REQUEST FOR INFORMATION (RFI)

PROJECT :	BKK2	R.F.I. NO. :	523213-01-RFI-AR-0025
TO :	CTA	ATTENTION :	CTA
SUBMITTED DATE:	19-Jan-26	NEED REPLY BY DATE :	26-Jan-26

SUBMISSION OF :	<input checked="" type="checkbox"/> Q&A	<input checked="" type="checkbox"/> Drawing	<input type="checkbox"/> Document	<input type="checkbox"/> Others (as specified below)
SUBJECT : Request for Information - Confirm for the Final Height of HMI Display from Fan Wall unit (FWU) with Respects to Human Ratio.

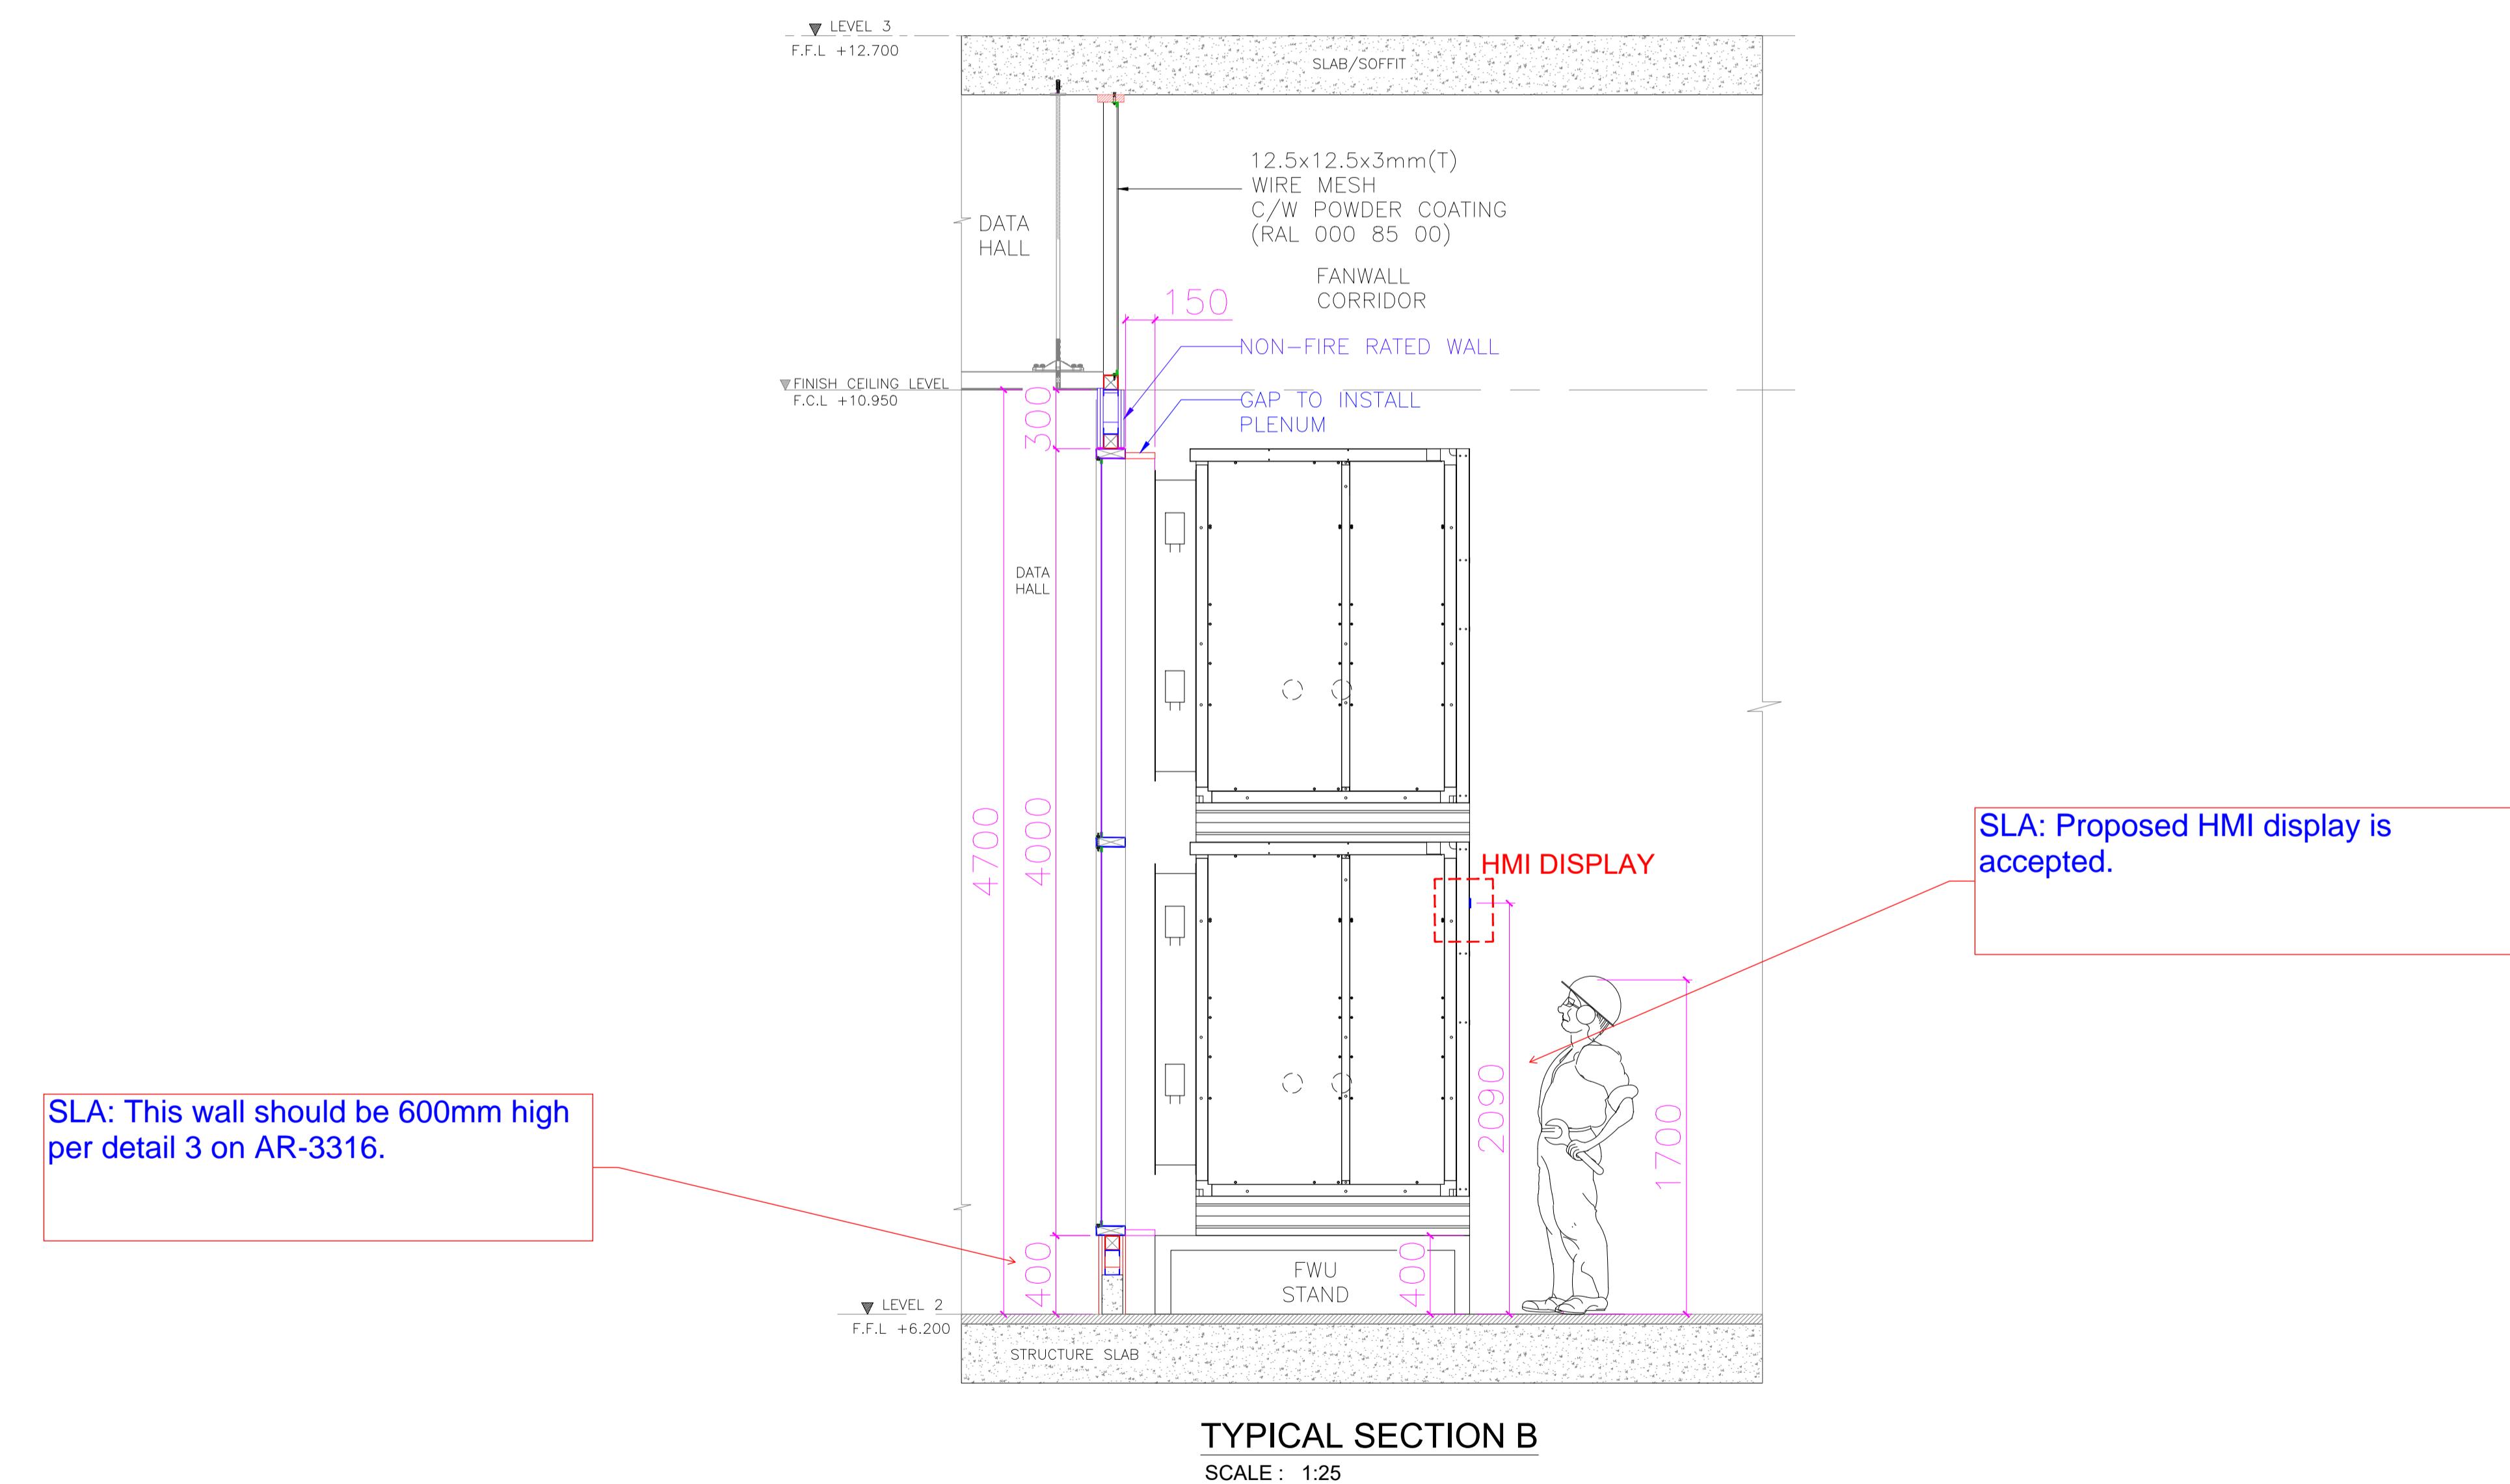
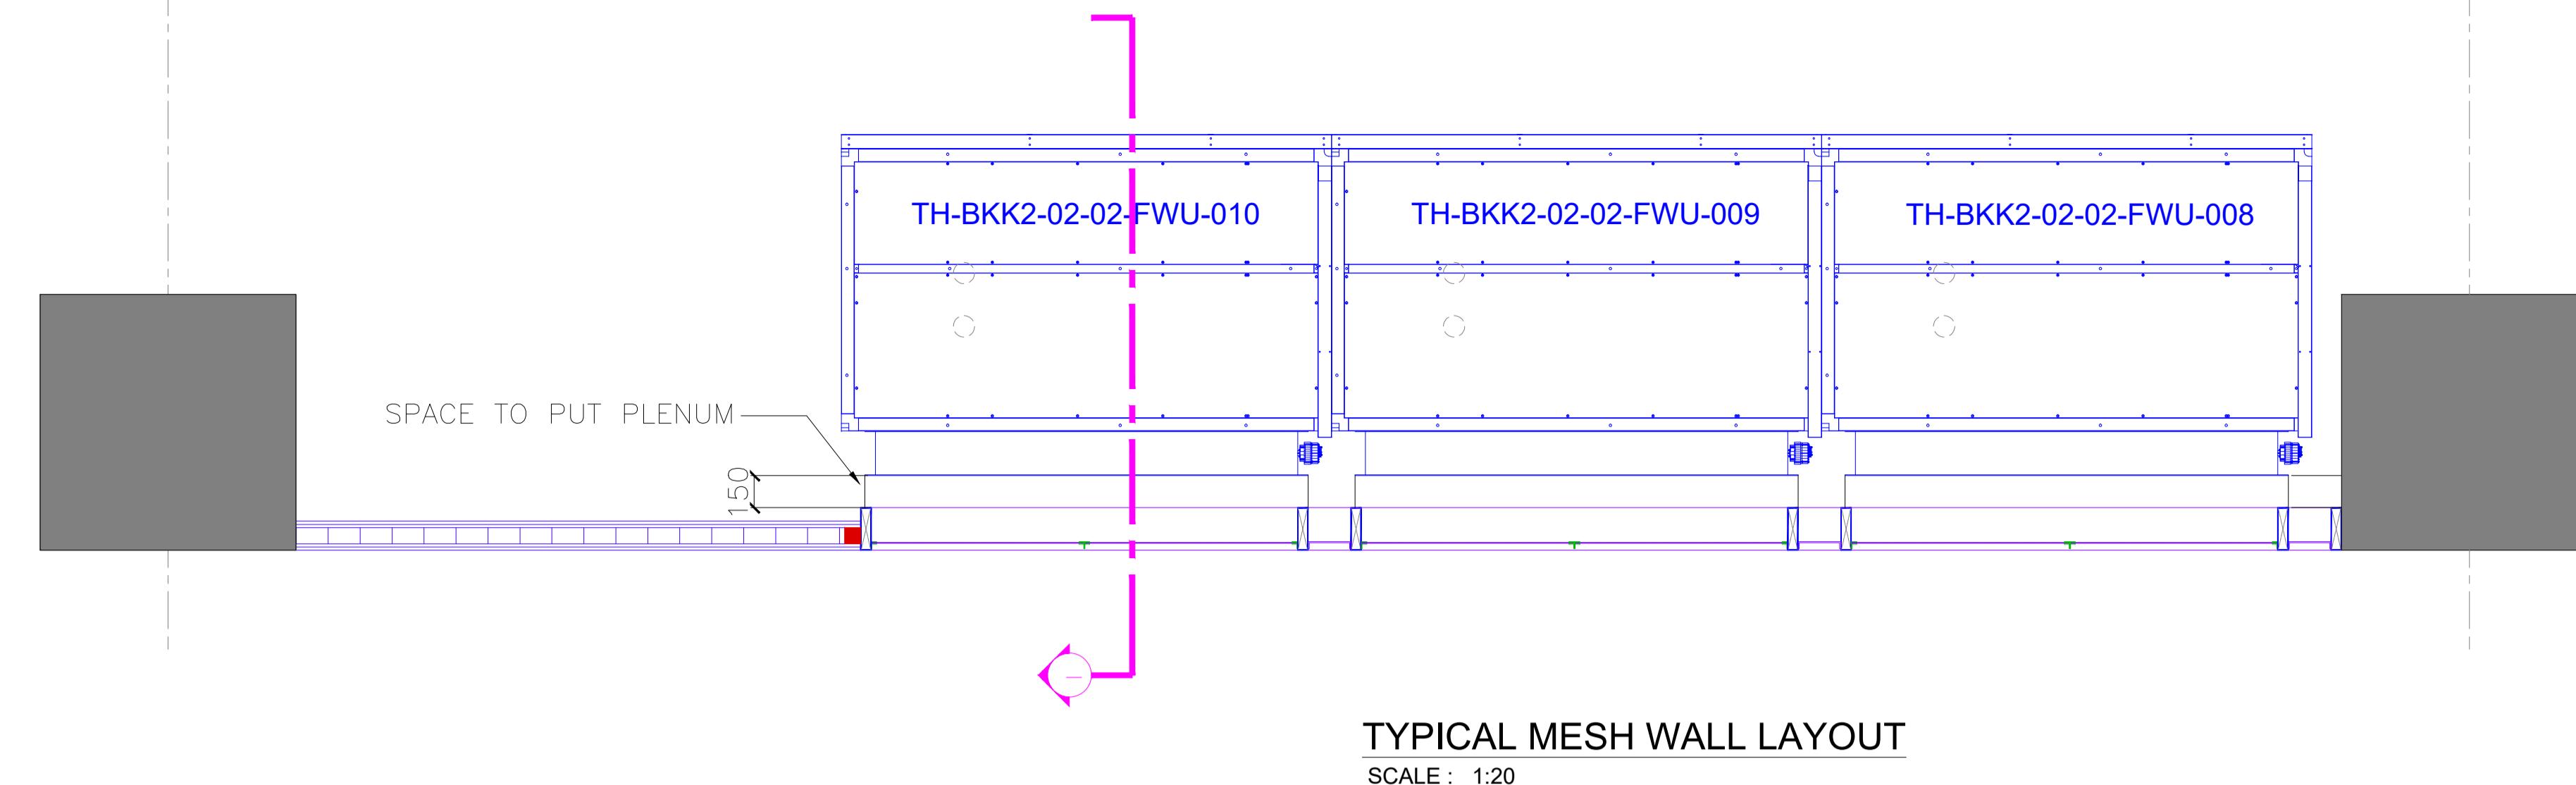
GAA Would like to Request confirmation for the final height of HMI Display from Fan wall unit (FWU) with respects to human ratio.

1. HMI Display which includes built-in Fan wall Unit is **1.69m.** from floor level. Fan wall stand is needed to include to hold Fan wall unit.

The Fan wall stand height is 400mm. so that the final height where HMI Display exists will be at **around 2.1m** height.

This height is beyond standard human ratio to look at the display and future maintenance.

Kindly see the attached file for sectional view.

The HMI needs to be in an ergonomically friendly position where it easy to access,
use and maintain without the need to steps or ladders etc. GAA are to immediately
coordinate with Canatec to ensure the HMI is in a satisfactory position.

SLA: Please refer to the notes in the attached markup.

The height from consultant's response is for guideline. However, the location of HMI relates
to service and maintenance issue. Contractor shall come back with more propose section view
to demonstrate when operator stand on ladder step.
